CLAYTON COUNTY WATER AUTHORITY

FLINT RIVER OUTFALL REPLACEMENT – PHASE 1A

A D D E N D U M # 1

Dated: July 28, 2015

DESIGN BY:	DATE:	04/15/2015
CCWA	JOB #:	814-08
DRAWN BY:	DRAWING #:	ES-1
WVB	SCALE:	1" = 40'
CHECKED BY:	SHEET NUMBER	12 OF 18

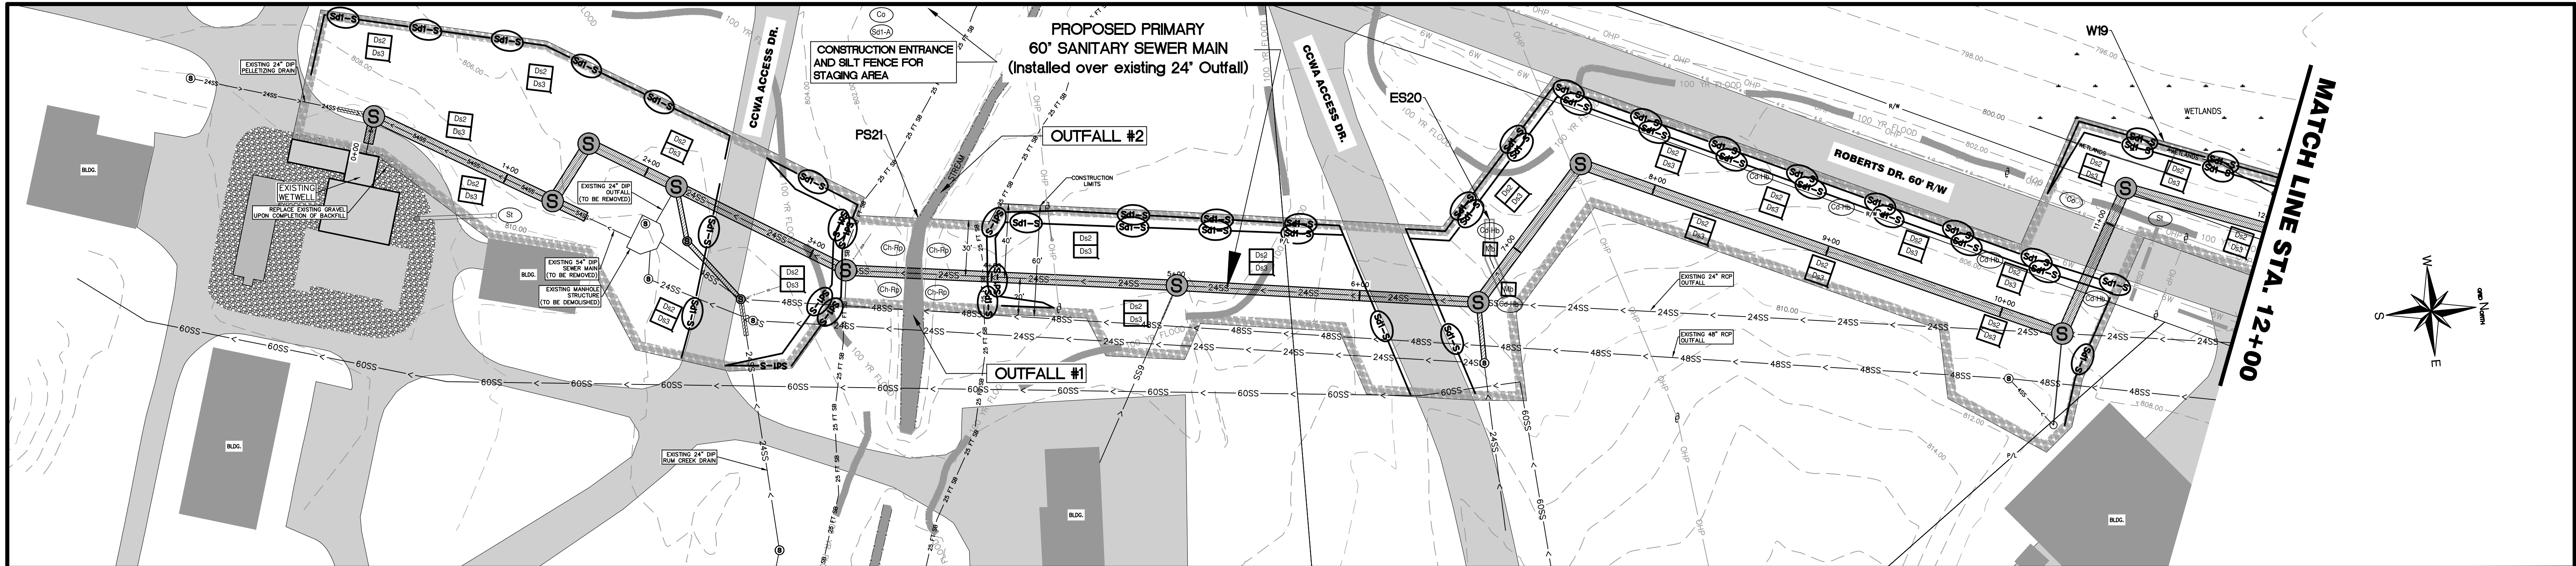
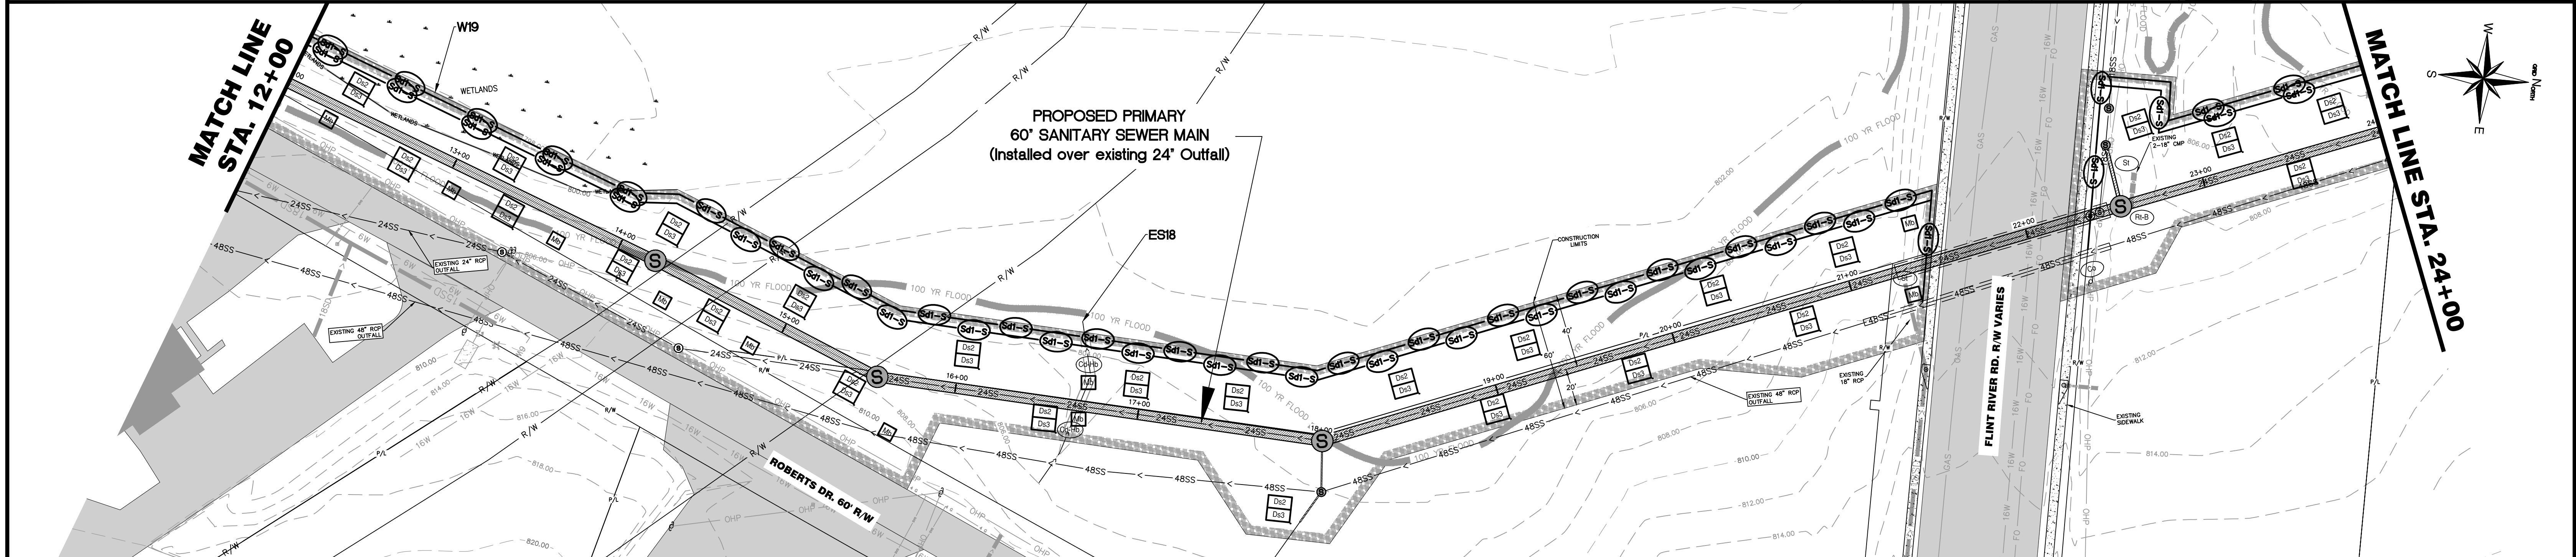
DATE:	NO.:	DESCRIPTION:
7/2/2015	1	PROVIDE DOUBLE ROW OF SILT FENCE AS SHOWN ON DRAWINGS

DESIGN BY: CCWA	DATE: 04/15/2015
DRAWN BY: WWB	JOB #: 814-08
CHECKED BY:	DRAWING #: ES-2
	SCALE: 1" = 40'
SHEET NUMBER 13 OF 18

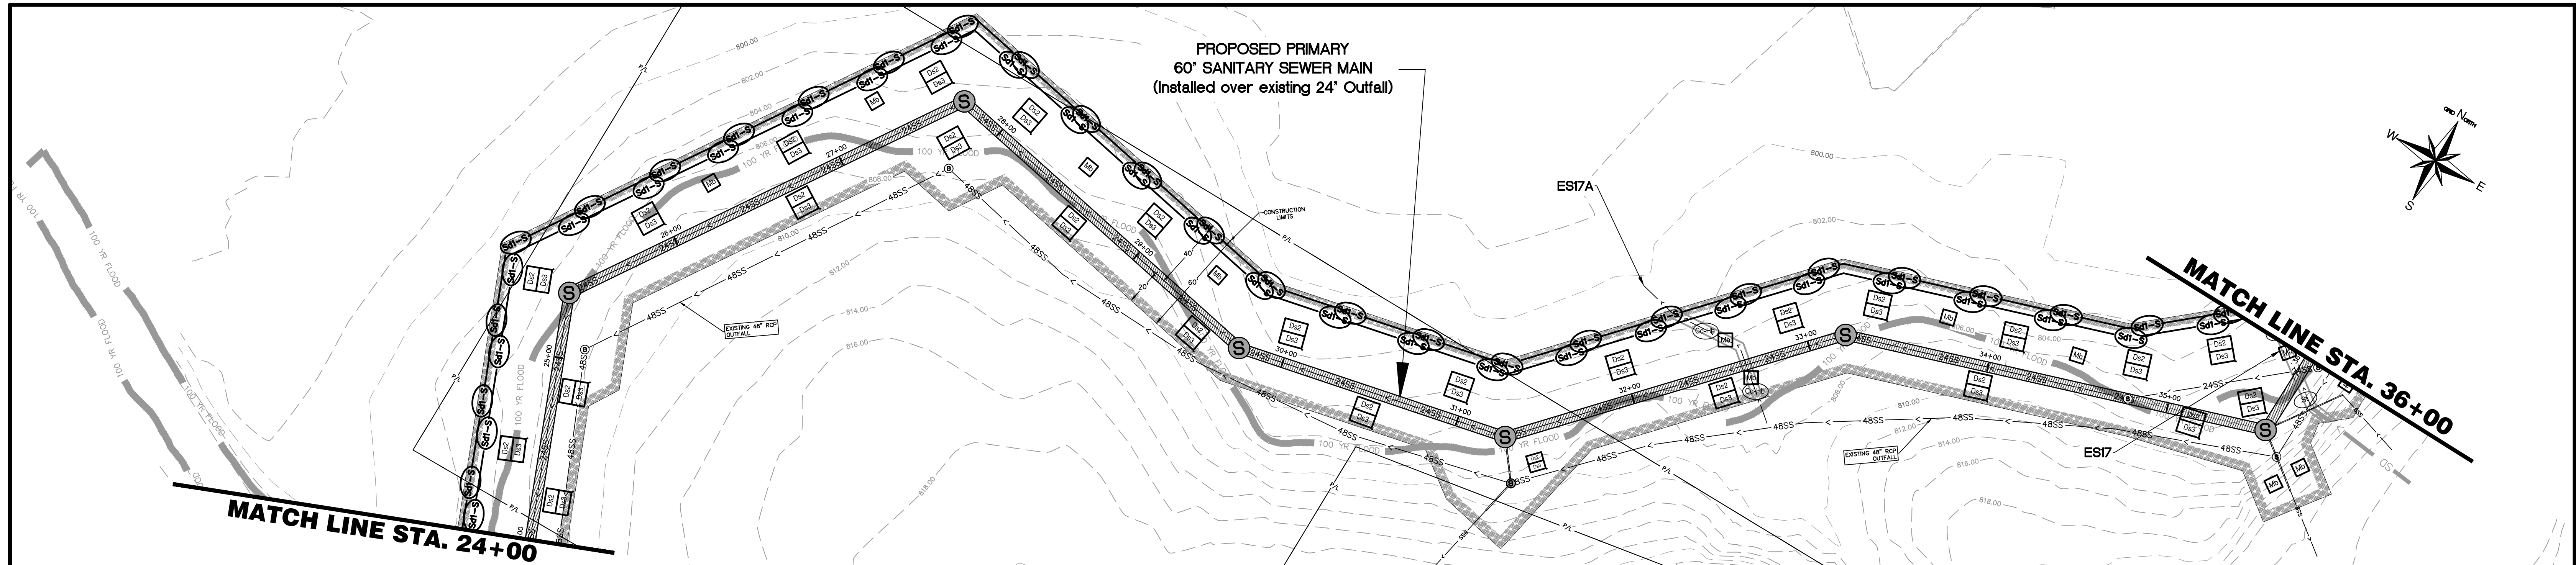
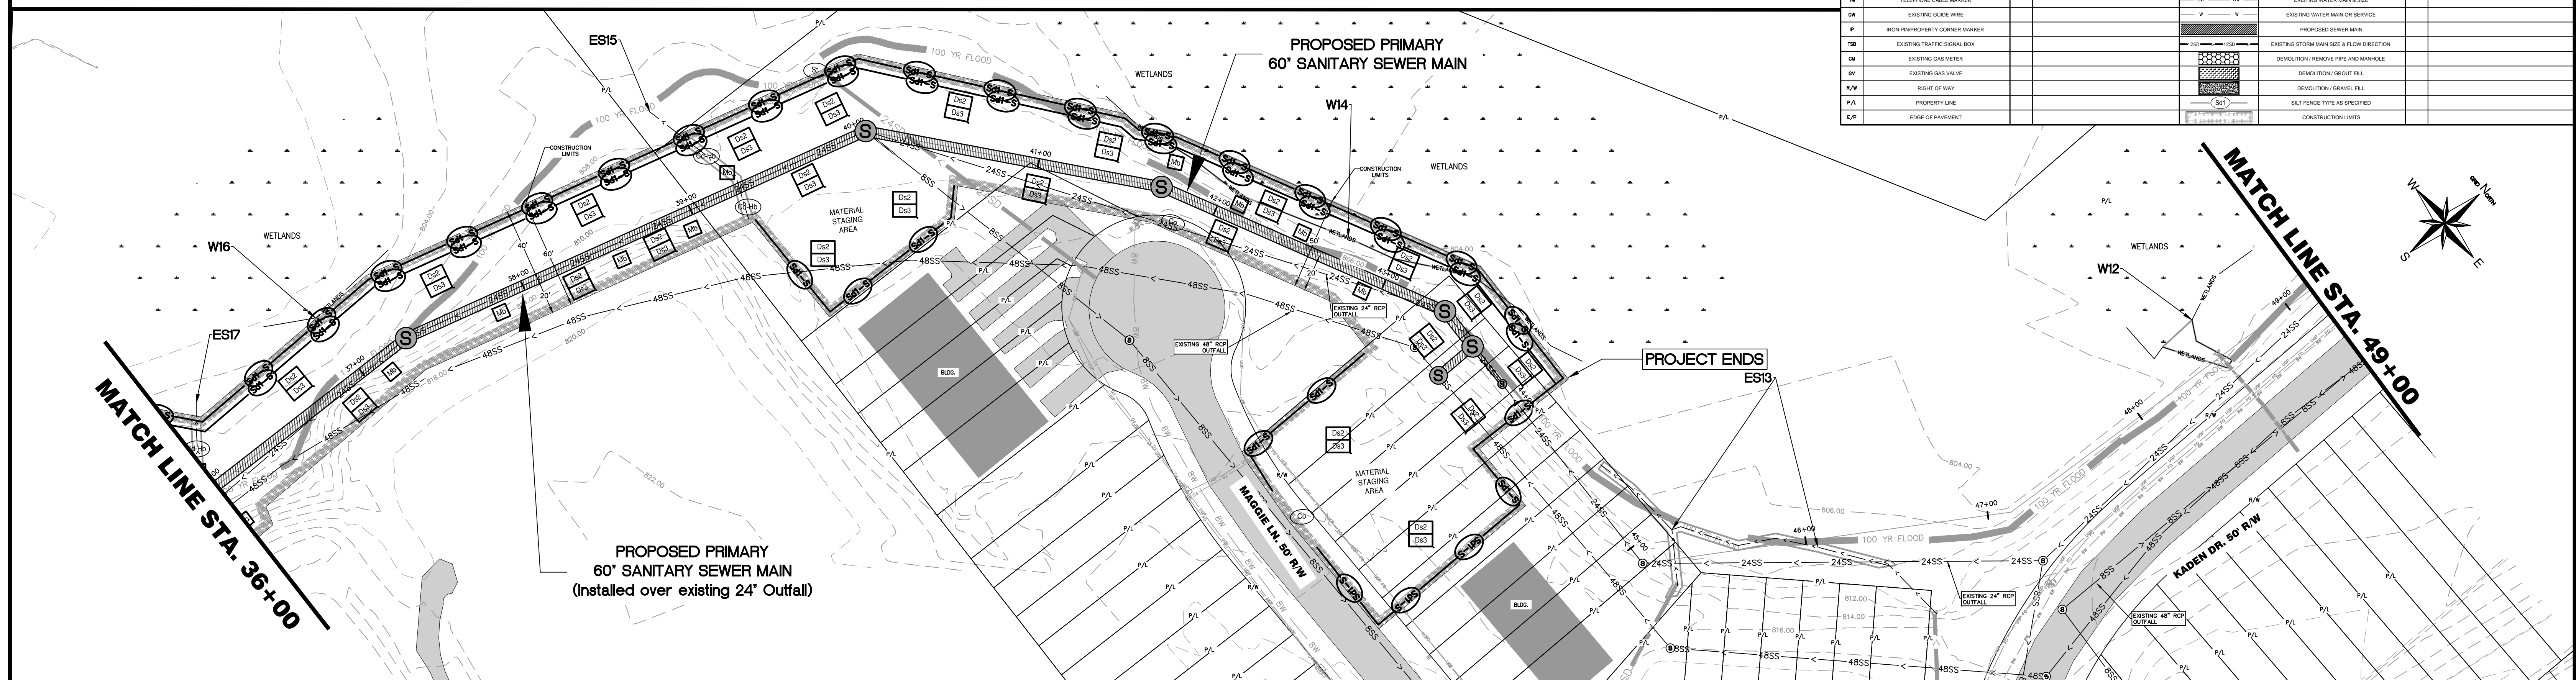
DATE:	NO.:	DESCRIPTION:
7/2/2015	1	PROVIDE DOUBLE ROW OF SILT FENCE AS SHOWN ON DRAWINGS
